# 1) Remove Collimator 3043 (12m) and replace with original beam pipe.

## **2) Remove Collimator 3076 (25m) and replace with original beam pipe.**

### **3) Move 12m Collimator (3043) to downstream LER.**

Chamber 3043 prior to collimator installation

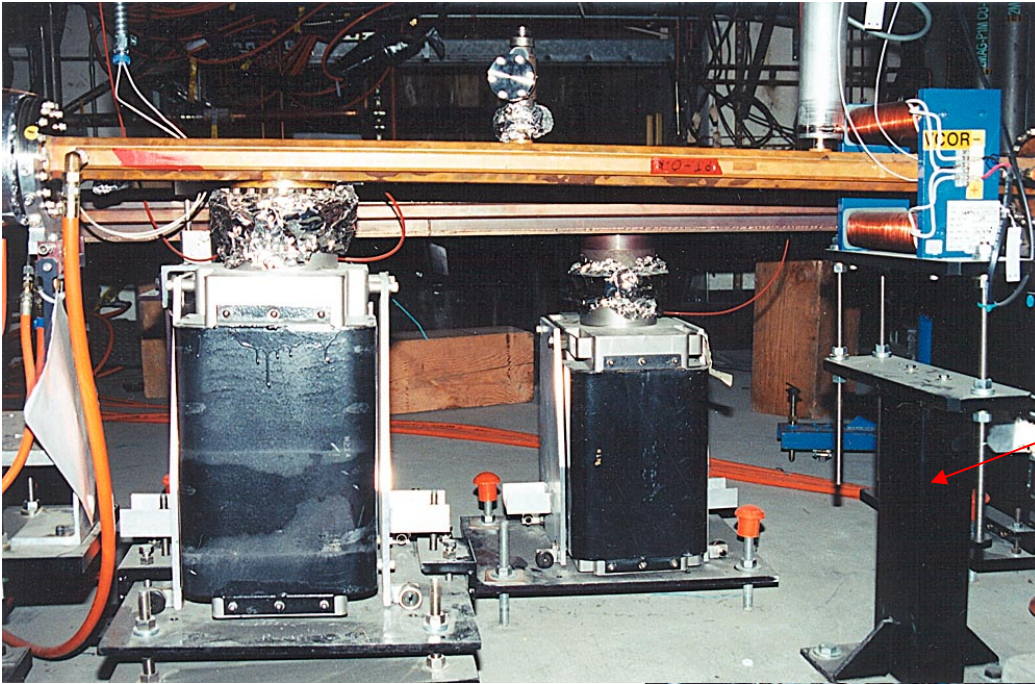
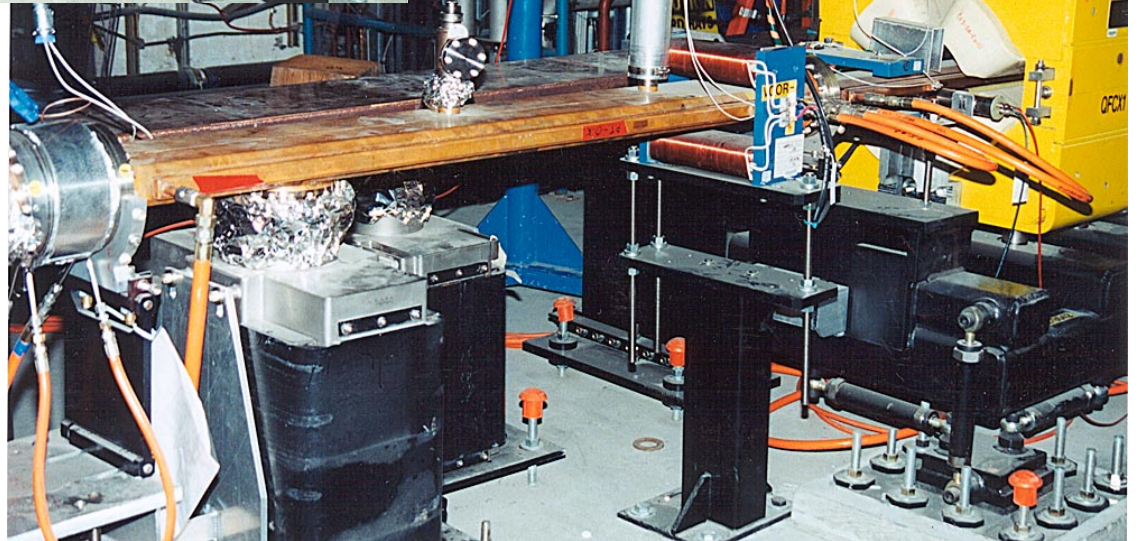
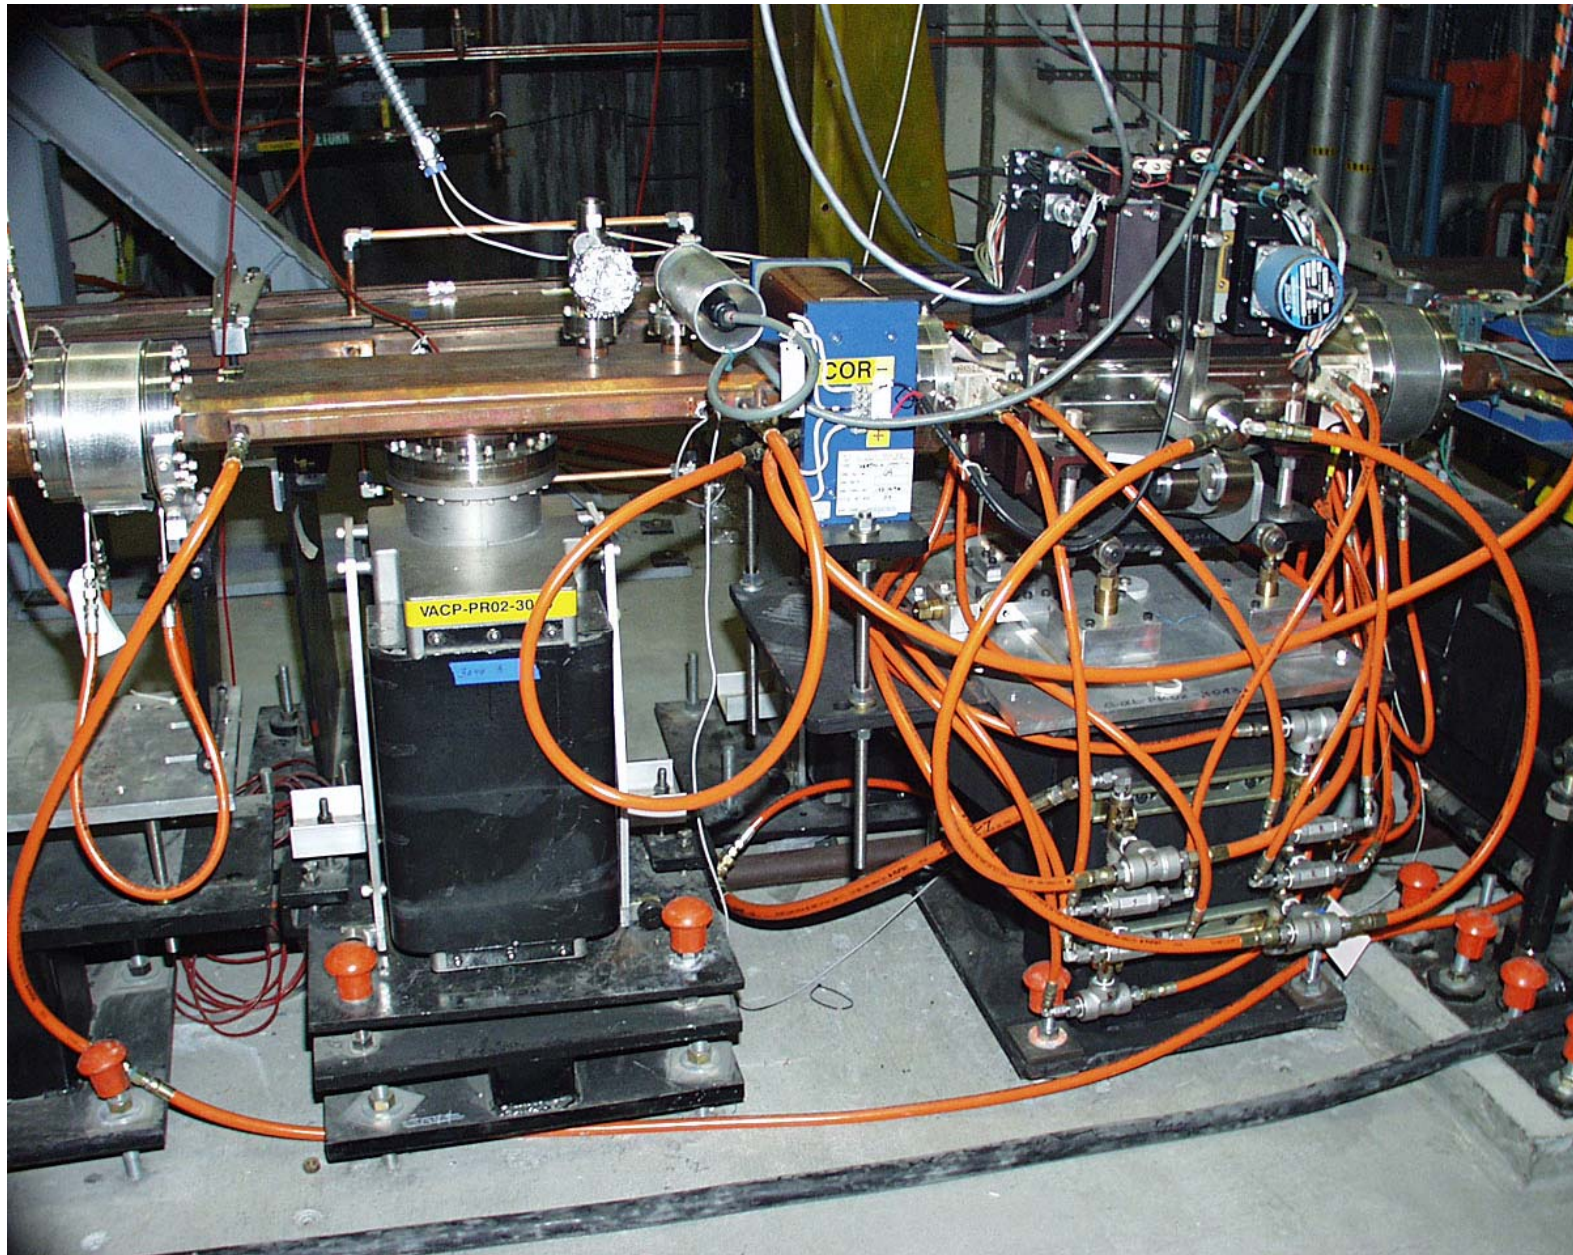
- Original beam pipe has been located in storage and can now be cleaned (HEPA vacuum and swab) and baked after solenoid windings have been removed.
- Corrector support has not yet been located
- Note that the corrector was moved upstream to make room for the collimator.
- Downstream bellows will be removed to make way for the original beam pipe.
- Upstream bellows and chamber support, vacuum gages and ion pump are all unchanged.
- Shield wall should probably be left in place.

Corrector stand not yet located

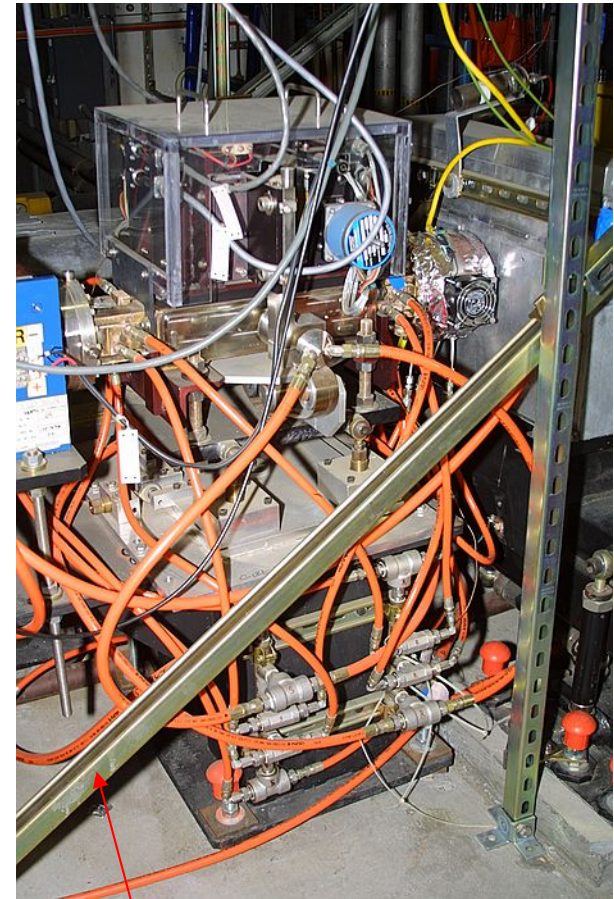
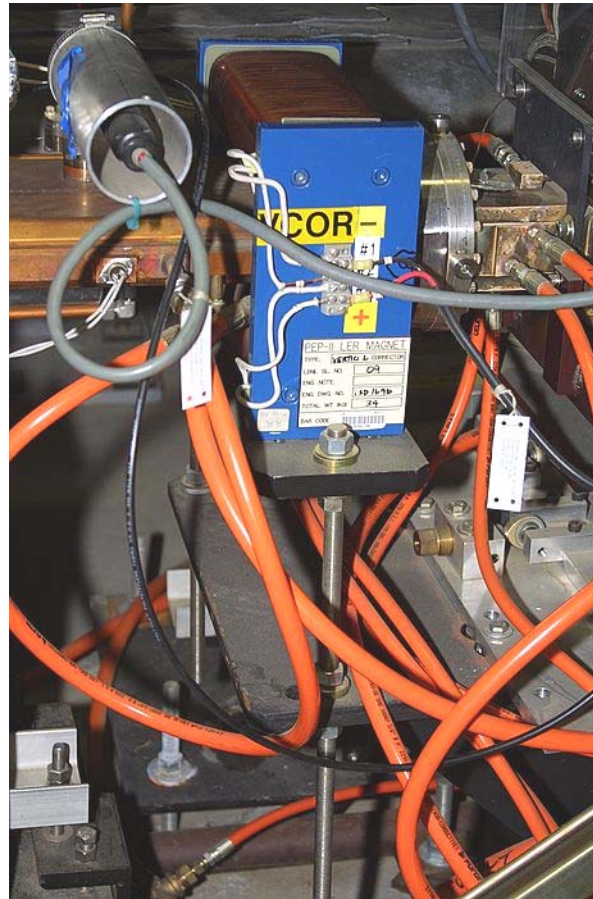
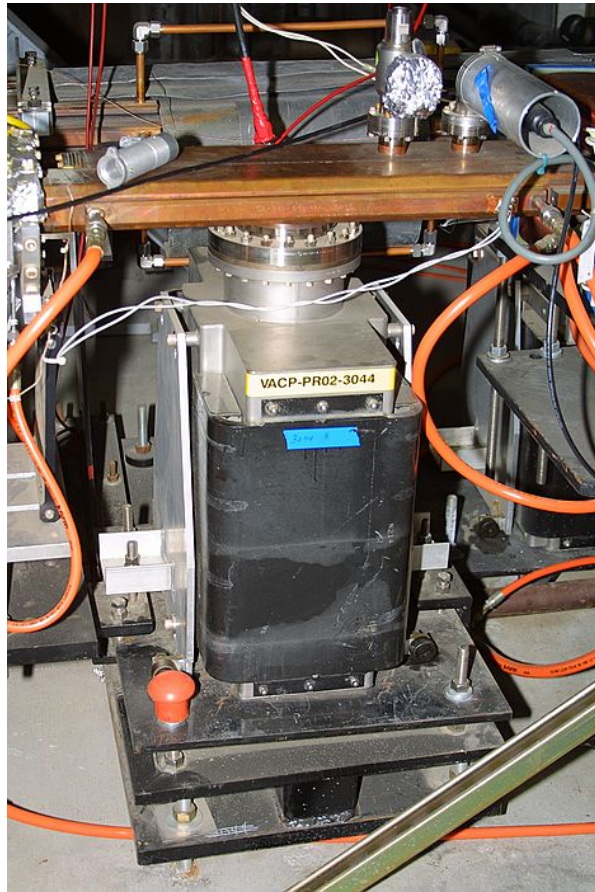
Unistrut bracing to shield wall may need to be temporarily removed to enable hoist access to collimator

Chamber 3076 prior to collimator installation

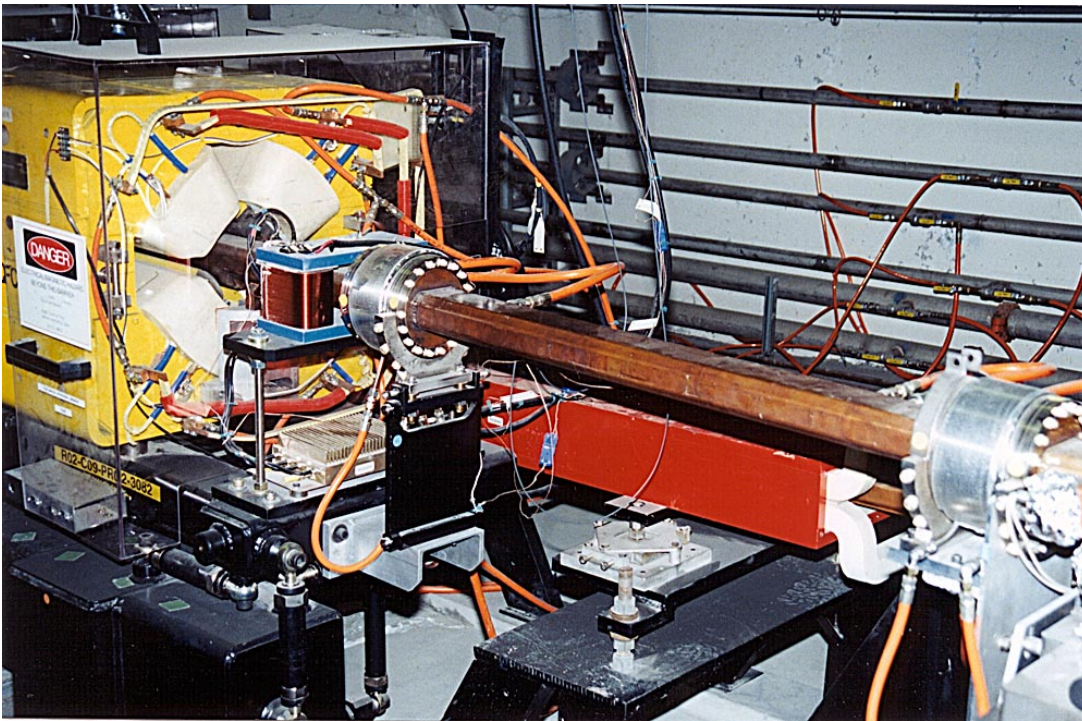
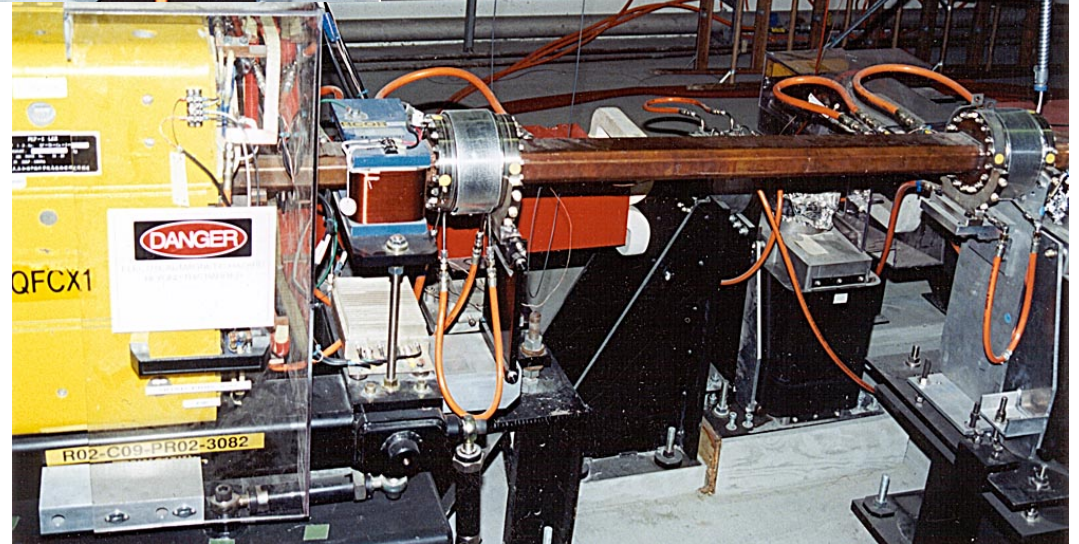
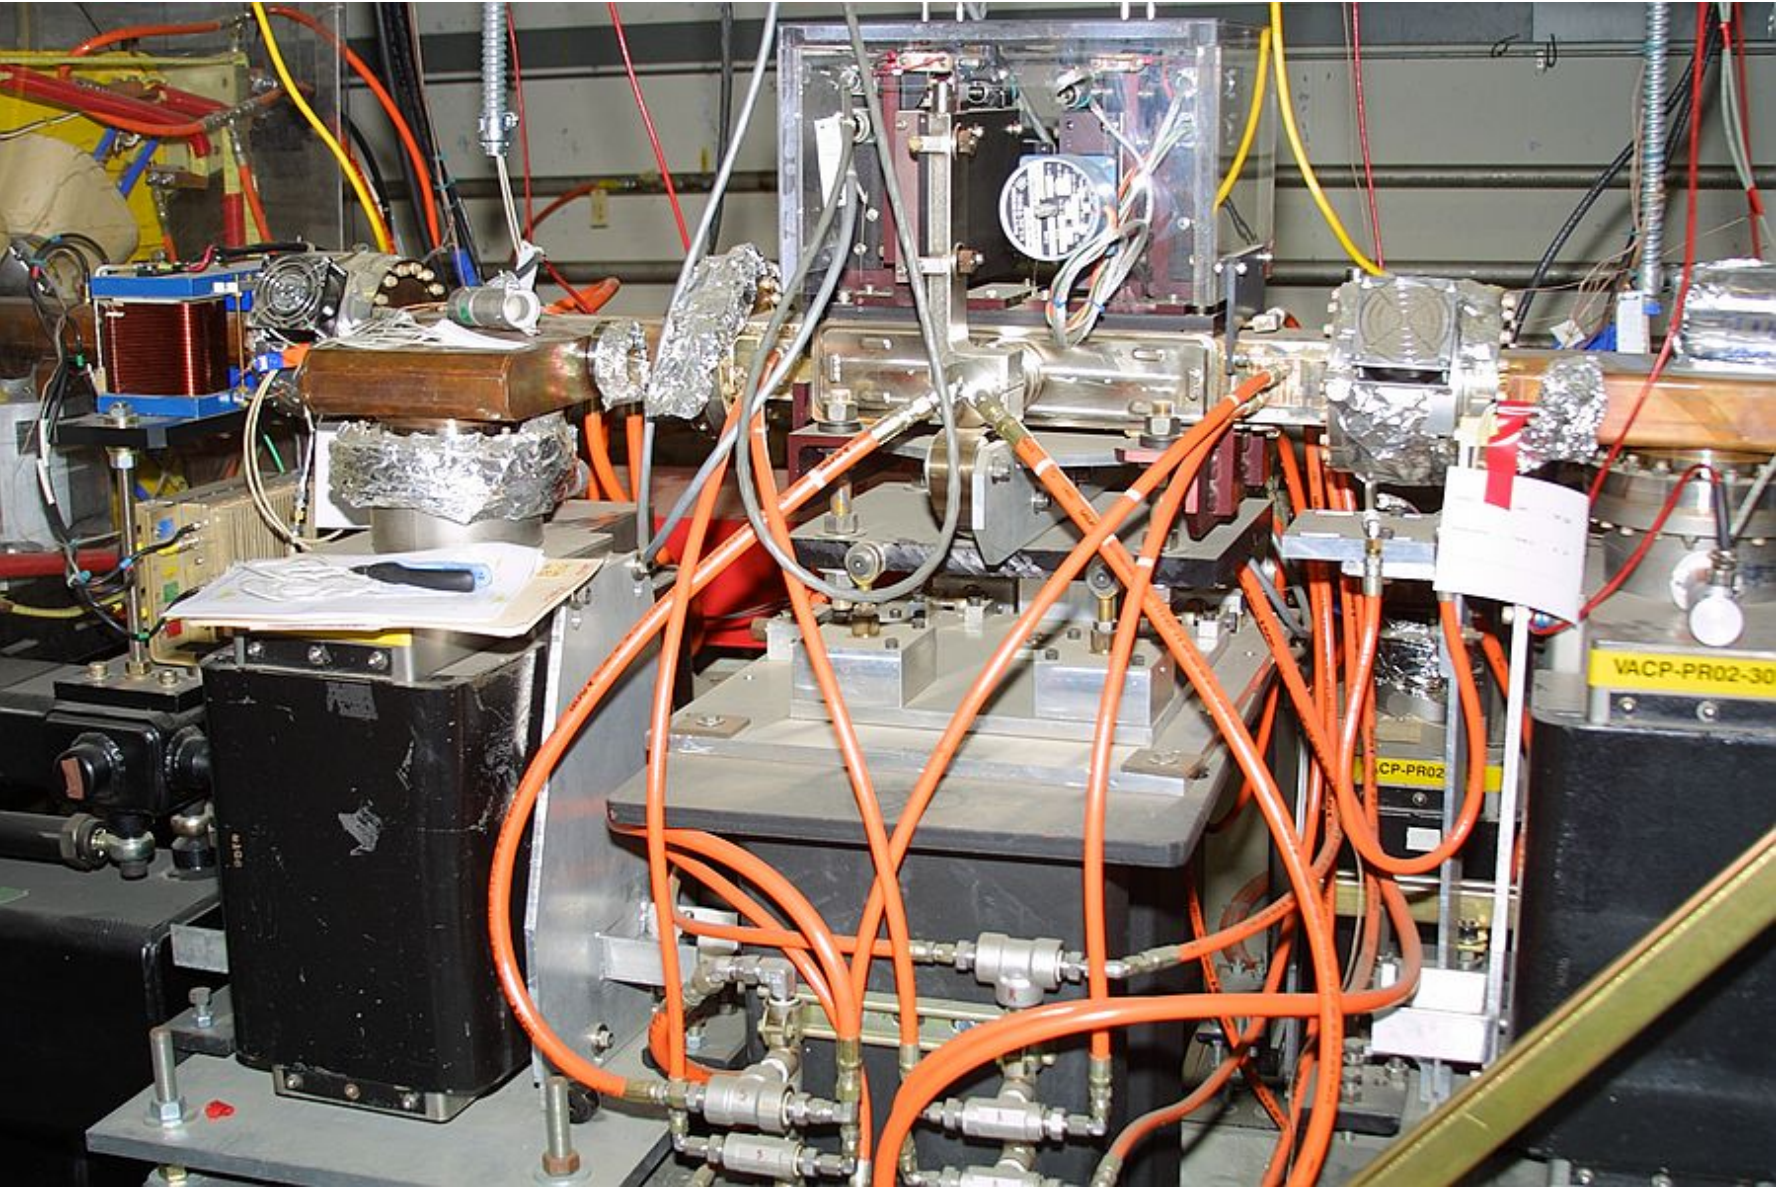
- Original beam pipe has been located in storage and can now be cleaned (HEPA vacuum and swab) and baked after solenoid windings have been removed.
- Corrector supports have not yet been located.
- Ion pump will be removed.
- Existing bellows pair will be reused.
- Shield wall should probably be left in place.

Chamber supports not yet located.
